20220411-ACP-2020-092 Stage 2 Engagement

Annex A to Inclusion of FJAs into UK AIP (ACP-2020-092) – Airspace Change Proposal Stage 2A: Engagement

NATS Response to ACP-2020-092 Stage 2 Engagement

Change Sponsors response to NATS feedback to Stakeholder Engagement ACP-2020-092

Note 19 MORAY CTA 12, CTA 13:
Activation of the airspace will be during Exercise exercises as notified to facilitate access to ATS

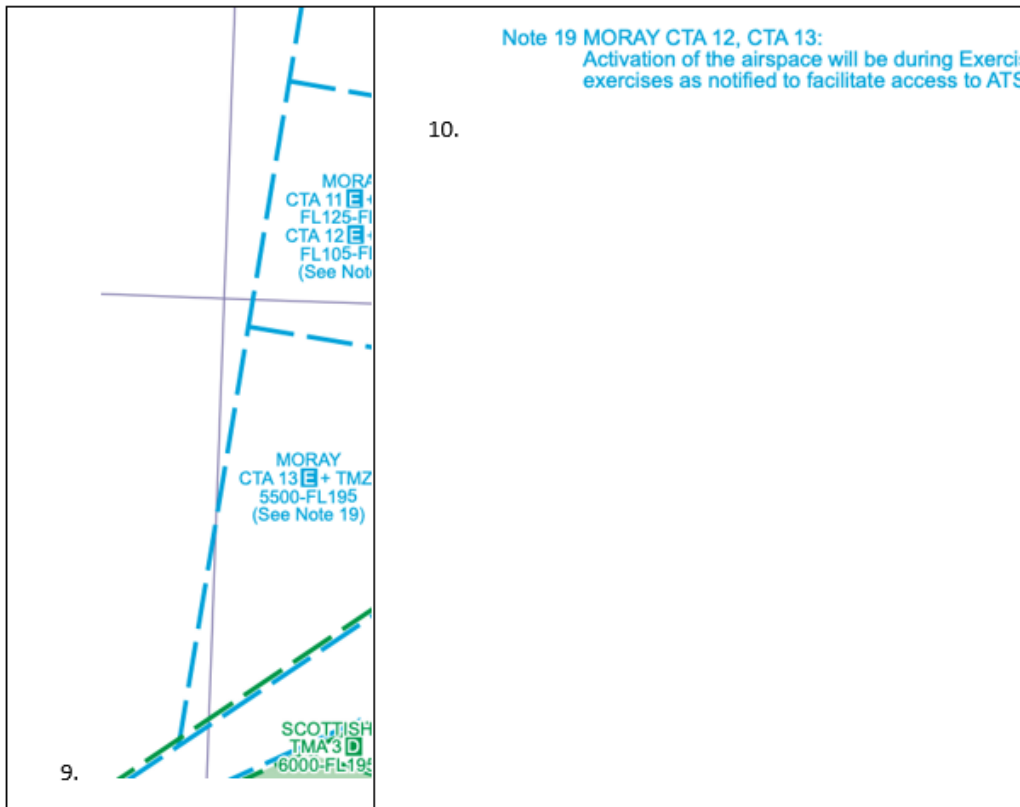
8. As a result of the reclassification of the Class E airway N560 to the MORAY CTA (section 12 & 13) (see diagram below), this element would also need to be captured in the advocated LOA e.g. when active the base level of the CTA is lowered. The lowering of the base level as a consequence of activation of the existing and proposed areas (specifically FJA South and Southeast) was instigated by the CAA following discussions with the British Gliding Association. (Previously it had a permanent lower level.) In short, when FJA South/S-East is active, ScTMA traffic in or outbound from the Oceanic interface via BRUCE (L602) is re-routed to use N560 or N562.

8. Thank you for bringing this to our attention; we will look to introduce a section that states when FJA(S) or FJA(SE) is active the base level of the CTA is lowered. We will look to have a meeting with yourselves to understand this issue better and so that the section in the LOA can be agreed upon.
